August 14, 2009
E-28173

Subject: Revision 2 to Transnuclear, Inc. (TN) Application for Amendment 11 to the Standardized NUHOMS® System, Response to Second Request for Additional Information (Docket No. 72-1004; TAC NO. L24080)

References: 1. Letter from B. Jennifer Davis (NRC) to Donis Shaw (TN), "SECOND REQUEST FOR ADDITIONAL INFORMATION FOR REVIEW OF AMENDMENT 11 TO THE STANDARDIZED NUHOMS® SYSTEM (TAC NO. L24080)," March 27, 2009

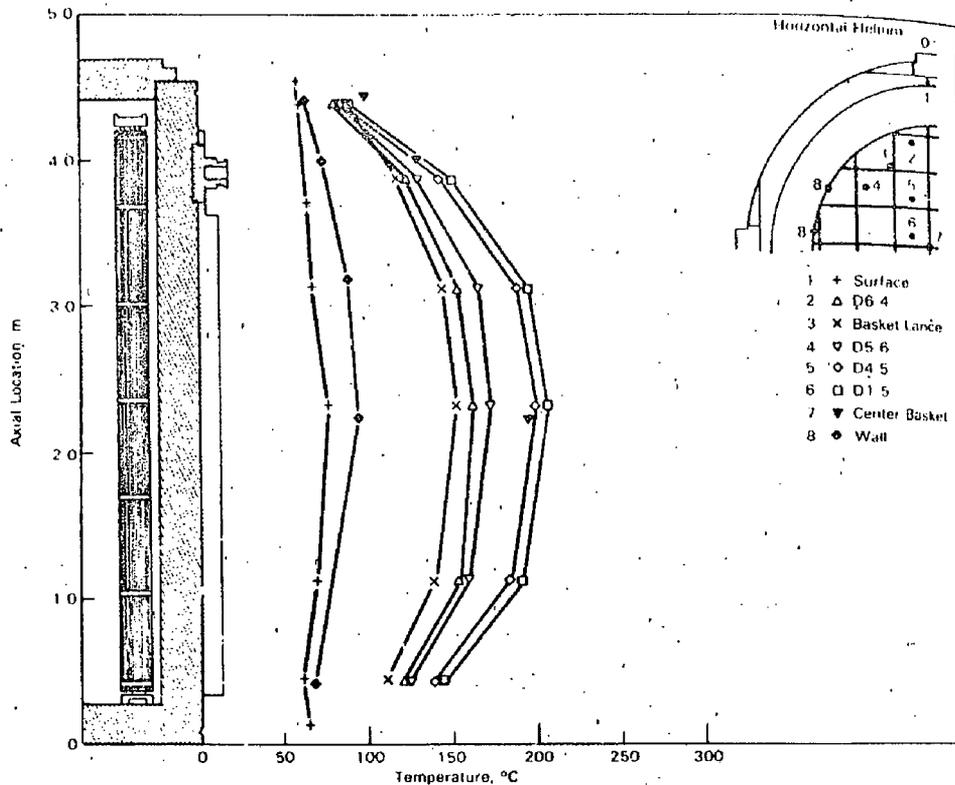
- 3.1 Justify that the assumption of a uniform heat flux at the transfer cask outer shell is a conservative representation of DSC/TC system within the supplemental shielding, and demonstrate that it can produce a conservative estimate of the temperature distribution on the transfer cask outer shell.

In the FLUENT model of the OS197L on the transfer skid enclosed with the supplemental shielding, the assumption of a uniform heat flux at the transfer cask outer shell is a significant simplification in the boundary conditions. It does not account for the variation in heat transfer on the transfer cask shell, due to variation in the surface heat transfer coefficient around the circumference of a horizontal cylinder. It also assumes that the heat flux is uniform along the entire 183.85-inch axial length of the neutron shield, as well as around the circumference of the 40.18-inch diameter neutron shield. (Note that this temperature distribution provides boundary conditions for the next step in the analysis, using a 2D ANSYS model of the OS197L transfer cask.)

Response to 3.1

Physical Testing: *The use of a uniform decay heat flux is validated by physical test data. For example, Figure 4-14 in the report, "The TN-24P PWR Spent-Fuel Storage Cask: Testing and Analyses," EPRI, EPRI-NP—5128, (PNL-6054), 1987, illustrates the measured temperatures on a horizontal TN-24P cask with a helium backfill. As seen, while the axial variation in the measured fuel cladding temperature clearly shows the effect of the decay heat peaking factor, the axial variation in temperature is largely not present for the temperature distribution at the edge of the basket (i.e., T/C #8) and is barely noticeable for the temperature distribution along the outer edge of the cask body (i.e., T/C #1). These results clearly demonstrate that the use of a uniform decay heat flux along the outer wall of the cask, especially if combined with end effects, would yield the same nearly uniform cask surface temperatures with a slight fall off at the ends as seen in the actual testing. Thus, the validity of using a uniform heat flux to support the calculation of the temperature distribution on the cask is supported by test data.*

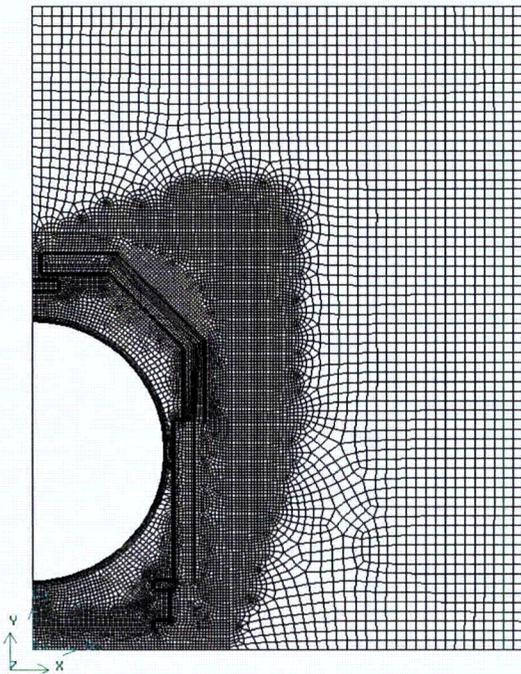
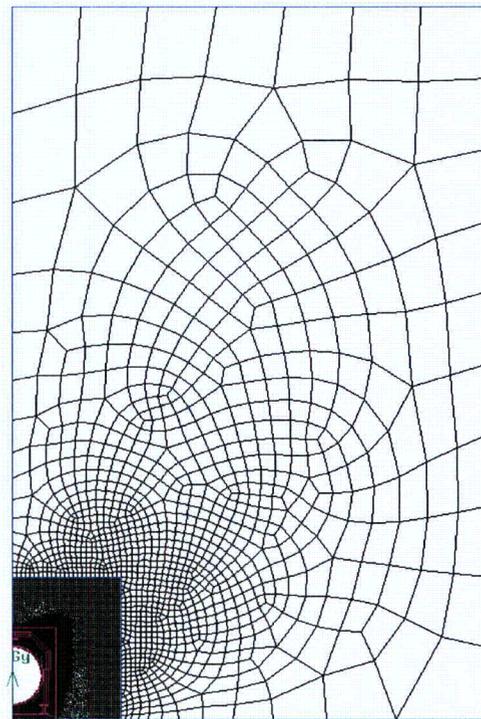
The size of the exterior fluid mesh in the FLUENT model of the OS197L transfer cask within the supplemental shielding may not be sufficient to extend to true ambient temperature. The mesh extends only about 1.5 to 2 IJD beyond the outer surface of the supplemental shielding into the surrounding air. Typically, the transition length is on the order of 5 to 10 L/D for thermal and velocity gradients in an infinite medium. The effect of truncating the distance to ambient would be non-conservative; it would overstate the steepness of the temperature gradient to ambient, resulting in a higher heat transfer rate than can actually be obtained.

Response to 3.3

By definition, the thickness of a thermal boundary layer is measured by the distance from the surface to the point at which the flow temperature is within 99% of the free stream temperature. Since the boundary layer thickness on the auxiliary shielding will not be more than a few inches thick at most (based on logic, hand calcs, etc), the 'steepness' of the temperature gradient is not over stated by the positioning of the ambient boundaries 75 to 100 inches away, as used in the CFD modeling. What can be affected by the proximity of the ambient boundary are the velocity and pressure profiles, which in turn have an impact on the boundary layer calculation. However, given the relatively low flow velocities and delta pressures associated with this case, the effect on the computed surface temperature was expected to be only minor and it was expected that these effects would diminish in proportion to the separation distance between the ambient boundary and the auxiliary shield wall. As such, no significant impact was expected by the selection of the ambient boundary positioning used in the modeling. To verify this conclusion, a sensitivity analysis was conducted using an extended computational mesh which extends the ambient boundaries from 150 to 660 inches in the x-direction and from 200 to 1,000 inches in the y-direction (see figures below). This increase in dimensions provides a transition length of 5 to 10

It was noted that the extended mesh setup has more difficulty in achieving a steady-state solution at the top of the cask shell in terms of a symmetric temperature distribution pattern along the z-axis. After numerous runs with variations in the under relaxation factors, pressure-velocity coupling method, and extended consultation with FLUENT technical support, it was concluded that the turbulent nature of the heat transfer at this portion of the cask shell was the root cause of the non-symmetry. This conclusion is supported by the fact that extending the number of iterations yielded a cyclic repetition in the temperature distribution pattern, but with little change in the resultant peak, minimum, and average cask shell temperature between iterations. While exercising the model in a transient mode and averaging the temperature results could be used to yield a time-averaged solution, the added effort was deemed not necessary for the purpose of addressing the sensitivity of the solution to the placement of the ambient boundary condition.

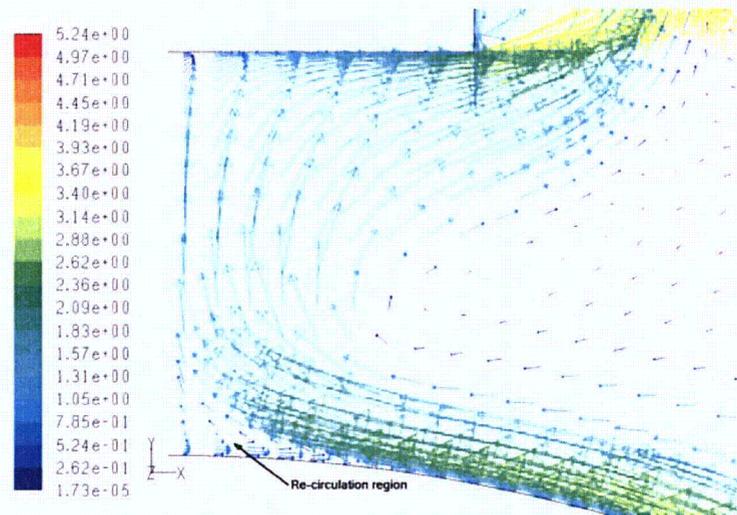
- 3.4 Justify that the analysis results presented in Figures W.4-5 and W.4-9 result from a conservative representation of DSC/TC system within the supplemental shielding, and demonstrate that this is a conservative estimate of the temperature distribution on the transfer cask outer shell.

The temperature graphics in Figures W.4-5 and W.4-9 show an off-set peak temperature location on the TC outer shell that does not appear to be consistent with natural convective heat transfer or with the flow field velocity vectors shown in Figures W.4-7 and W.4-8. (Note that this temperature distribution provides boundary conditions for the next step in the analysis, using a 2D ANSYS model of the OS197L transfer cask.)

Response to 3.4

point of flow stagnation and the centerline of the cask. A close examination of Figure W.4-8 will show the presence of this recirculation zone, although the scale of the figure makes it difficult. An enlarged view of the velocity field in this region of the model presented below clearly demonstrates the presence of the recirculation flow at the top of the cask. Since it is the stagnation zone that experiences the highest surface temperature, the temperature distribution illustrated in Figures W.4-5 and W.4-9 correctly depicts the location of elevated shell temperature at the region of the cask shell where the circumferential flow stagnates and detaches.

Although the figure above is for OS197L with a 24 kW heat load, a similar flow re-circulation zone exists for the OS197L transfer cask with a heat load of 13 kW and the justification provided in this response applies for the 13 kW heat load as well. See the revised text and the figure added in Chapter W.4 of updated SAR to address this RAI.
